**Overview:** Production error in version 1.0 harnesses; The immobilizer wire (orange/black) is in pin position #4 instead of pin position #5. Although an effort to correct the issue was made, some quantity of harnesses did get shipped before the issue was spotted. We are advising to inspect the harness BLADE connector before attempting to install harness or program the module. This issue is not known to affect the version 2 harnesses, which require no modification.

**Overview:** Early versions of the FTI-STP1 harness require modification for **automatic transmission (AT)** applications, some of the product was able to be modified before release, but a small quantity was released without modification.

## FTI-STP1: Installation and Configuration Notes

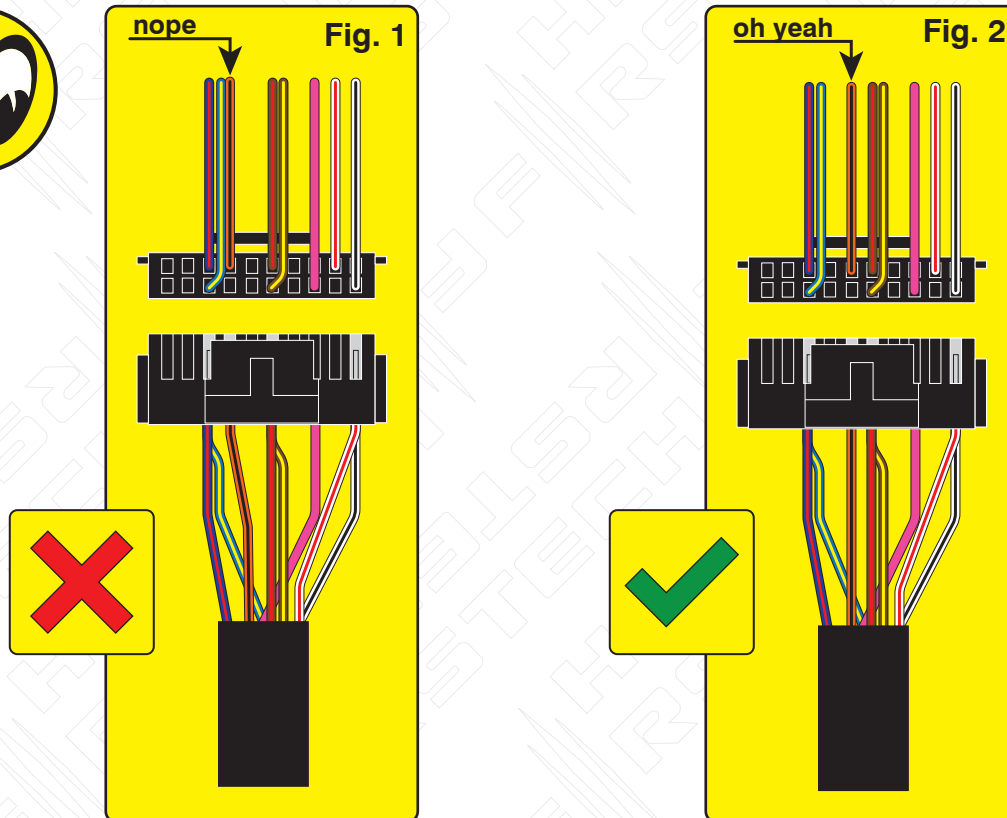
**Issue:** Module fails to program correctly to vehicle, does not allow the vehicle to be remote started.

**Correction:** Step 1.) Locate the orange/black wire and confirm whether it is positioned as illustrated in Fig. 1 or Fig. 2. If the wire is as illustrated in Fig.1, proceed with Step 2 through 5 and complete the repair procedure outlined, if the wire is as illustrated in Fig. 2, correction is not necessary, proceed with harness installation and module programming.

**Step 2.)** Using a pick, lightly depress the catch that secures the terminal in the housing then remove the wire and terminal from the housing.

**Step 3.)** Using a fine tip razor or utility knife, insert the blade beneath the terminal catch and raise it slightly, so that it can be reused to secure the terminal when reinserted into the BLADE connector housing.

**Step 4.)** Refer to Fig. 2 for correct position of the orange/black wire (next to brown/red) then reinsert the terminal, pressing lightly until the catch 'snaps' into place, securing the terminal in the connector housing.

**MODIFICATION REQUIRED FOR A/T APPLICATIONS, ONLY WITH v 1.0 HARNESS**

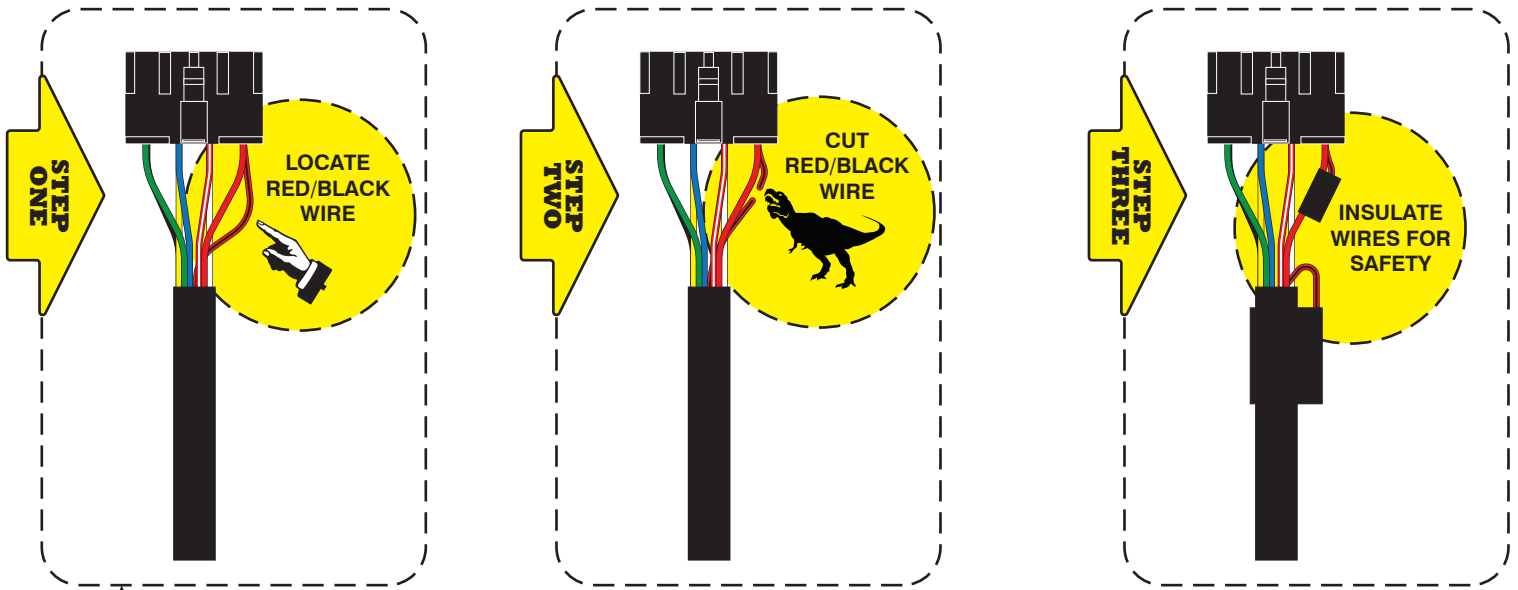
**Issue:** The FTI-STP1 T-harness has been designed to be compatible with A/T (automatic transmission) & M/T (manual transmission) applications, but due to an oversight in early production runs, the selection was defaulted to M/T mode.

Using a harness configured for an M/T application, in an A/T equipped vehicle, could result in vehicle module damage, it is advised that the harness be returned to A/T mode before installation in vehicles equipped with an automatic transmission.

**Correction:** Locate the **red/black (+ Clutch)** wire provided in the CN1 connector of the main harness assembly. Cut the **red/black** wire, either flush to the CN1 connector, or leaving enough wire exposed so that you can insulate and secure the ends of the wire that remain after cutting. Insulate each of the remaining ends of the **red/black** wire and secure to prevent any possibility of a short circuit. **If the red/black wire has already been disconnected, no further modification is required for A/T applications**

**MODIFICATION NOT REQUIRED WHEN USING FTI-STP1 (v 1.0) HARNESS IN M/T APPLICATIONS, OR WHEN USING THE FTI-STP1 (v 2.0) HARNESS**

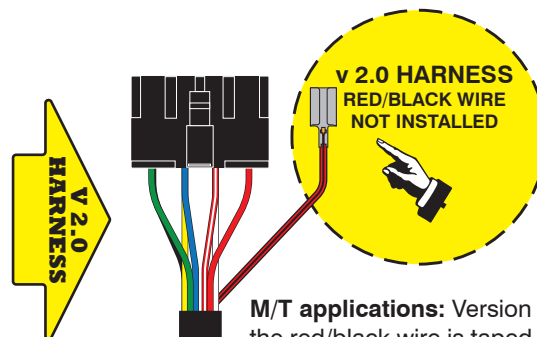
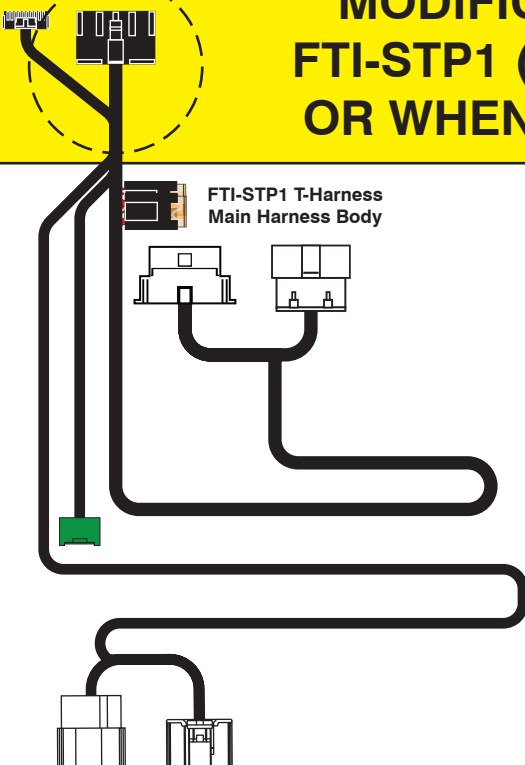
**M/T applications:** Version 2.0 harness, the red/black wire is taped to the main harness when shipped, and must be installed in the CN1 connector when installed.

**A/T applications:** Leave the red/black wire taped to the harness, it is not required for A/T applications
